TAL-CO SUPPLEMENTAL INSTRUCTION #06			
Project Name:	RW TOMLINSON - NEW HEAD OFFICE		
Project Location:	100 Nortel Drive, Ottawa, Ontario		
ARCH. SI #:	N/A	Issued By:	Chris Simpson
STRUC. SI #:	SSI #4	Date Issued:	September 28, 2016
MECH. SI #:	N/A	Revision #:	N/A
ELEC. SI #:	N/A	Revision Date:	N/A

Title: Revision to concrete beam schedule

STRUCTURAL SITE INSTRUCTION

STRUCTURAL SITE INSTRUCTION No.: 004

CONCRETE BEAM SCHEDULE (H x W)

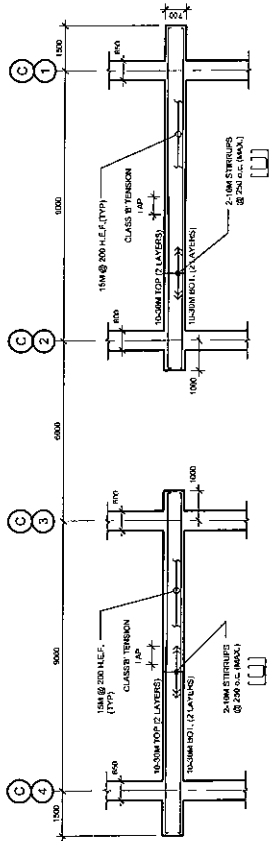
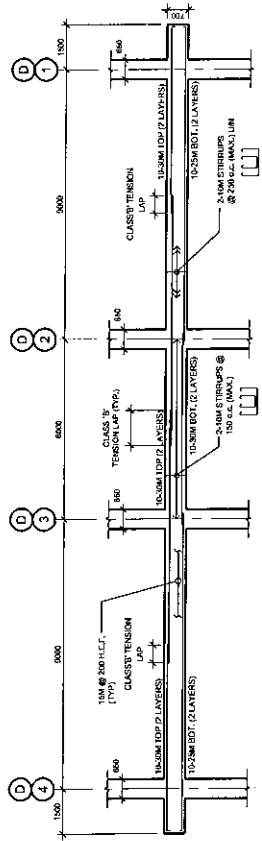
Revise the beam schedule dimension note title to read H x W not W x H to match the detailing of the beams in the schedule.
